From: [Kilbee, Christina](#)
To: [Planning Administration](#)
Subject: FW: Ref 210540 for new Food and Drink Quarter
Date: 14 June 2021 12:20:32
Attachments: [image001.png](#)
[image002.png](#)
[image004.png](#)
Importance: High

Subject: Ref 210540 for new Food and Drink Quarter

Construction of new food and drink quarter (constructed using shipping containers) including restaurants and cafes (Class E) and Bar (Sui Generis) and use of external spaces **for erection of beach huts**, seating, new terrace, refuse store, public toilets, pergola, landscaping, **boundary treatment** and associated works.

2. Location Plan and Block Plan

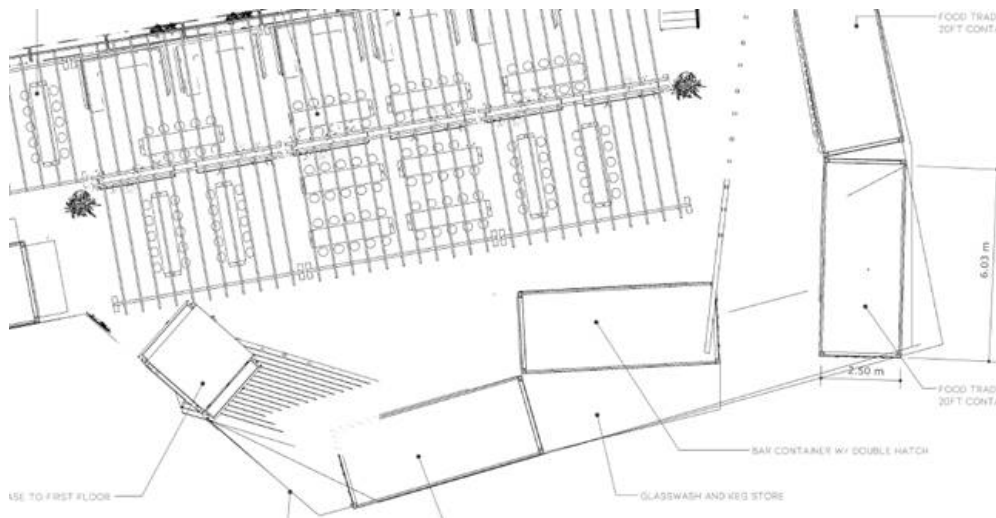
The 'red line' site area delineates the area of the application site. Noted.

A 'blue line' should indicate other land the applicant owns or has control over. I note the key on the submitted plan annotated blue line as 'market areas'. Please confirm you client has control over all these areas ?

Also re the 'loss' of the existing market compound – is this to be re located ?

- I can confirm that the applicant has control over all the areas shown on the plans.
- The existing market compound is largely unused, and so does not need to be relocated. A storage area is shown on the plans, in the south west corner which, from the applicant's extensive experience in running markets and daily conversations with the market traders at Hosier Street we know that there is space is sufficient for their needs.

4. Elevations

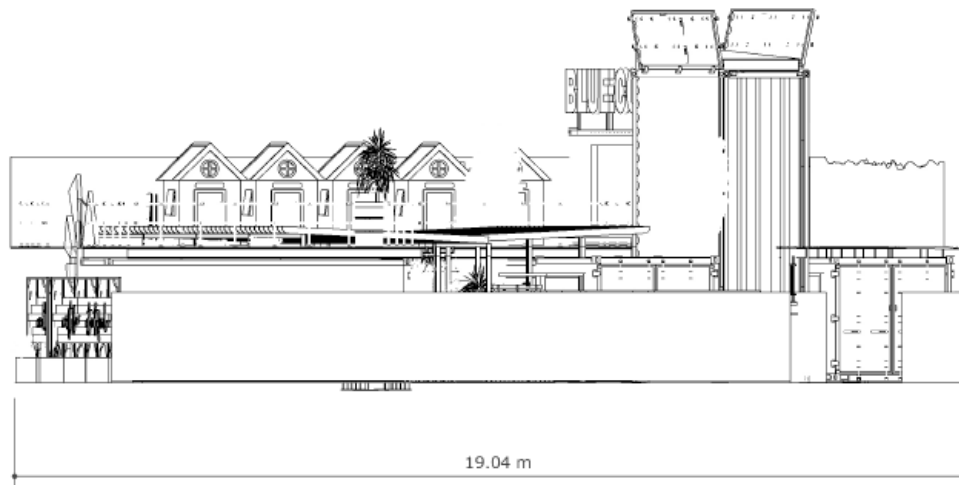
4 individual plans have been submitted : front, rear, left and right. Some graphic elements of these plans appear to be missing – is this a scanning issue ?

In relation to these plans they show the exterior of the site with the proposed boundary treatment which obscures the internal structures. There are no additional details of the internal structures including the beach huts and containers, which are the largest structures sought within the site. For example do the containers have windows and doors in ?

Also how is the toilet block provided ? How are the refuse area and storage area constructed ?

The insertion of the boundary treatment also obscures the floor level – which means I am unable to scale from the floor level to determine the heights of the structures within e.g. the beach huts shown below. These are set at first floor level therefore I need to be able to confirm what is visible above the existing substation? I also need to be able to assess the height of the stair tower and large scale supporting structures for signage from existing ground level.

You therefore need to submit sections through the site to show the existing ground level and internal structures; and provide details of the structures in relation to their dimensions and detailed appearance. I note some materials are set out on the submitted application form but this does not include the toilet block, raised deck and auditorium seating; or details of the boundary treatment which is indicated at ground and first floor level. The Heritage Statement makes reference 'to 6ft high fencing around the site' details of this needs to be clarified. Also is a green wall proposed along the back of the site ?

- The existing elevations are being updated for clarity and will be submitted ASAP
- Additional elevations are being prepared as requested and will be submitted ASAP

- Standard Beach Huts and Container details are being prepared and will be submitted ASAP
- We acknowledge that the adverts will be subject to a separate advertisement application which are being prepared.

- Site Sections are being prepared and will be submitted ASAP
- The toilet block is proposed to be a prefabricated building which will be clad in feather edge timber

- The storage area will be of tanalised timber and featheredge fence construction.
- The walkway/raised deck will be of 210mm RSJ construction with steel bracing with 8x2 tanalised roofing joists, a membrane overlaid to avoid debris / liquid from above and a 125 X 35mm decking over with a 5mm gap to allow for expansion and contraction.
